**USEPA-APPROVED  
TOTAL MAXIMUM DAILY LOAD (TMDL)  
FOR THE  
Río PUERCO WATERSHED – PART 1**

**AUGUST 10, 2007**

Figure D1: Annual Mean Discharge at USGS 08334000 (1925-2005)

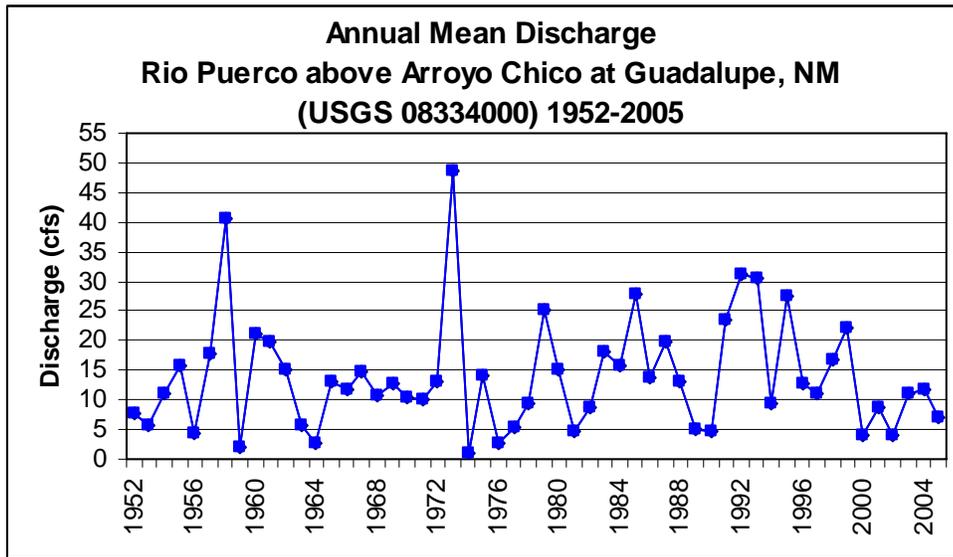
- *At and below the Village of Cuba, flows... combine with effluent from the Cuba WWTP to provide perennial flow... (page 4, 2.0 Background) There is no data to support this statement. What are the flows? When were they measured? How much is attributable to the effluent? Does the Cuba WWTP keep track of its' releases? How does a stretch between two (2) intermittent segments become perennial?*

- *No streamflow data are necessary... (page 17, 3.2 Flow)* There is serious question as to whether or not this stream segment is really a perennial stream. There is no flow data to support the New Mexico Environment Department (NMED) conclusion that this stream segment is perennial.

5. SWQB did not include flow data in the draft TMDL because flow is not a part of the Sedimentation/Siltation TMDL calculation. We have added available stream flow data, Cuba WWTP effluent discharge data, and observational field notes to Appendix D.

13. SWQB did not include flow data in the draft TMDL because flow is not a part of the Sedimentation/Siltation TMDL calculation. Available flow data has been included in Appendix D. However, as far as the perennial nature of the Rio Puerco (Arroyo Chijuilla to Northern boundary Cuba), the amount of water has been fully capable of continually supporting aquatic life (as in the various macroinvertebrate and fish samples collected by SWQB) and is supporting an existing, thriving, and expanding riparian plant community.
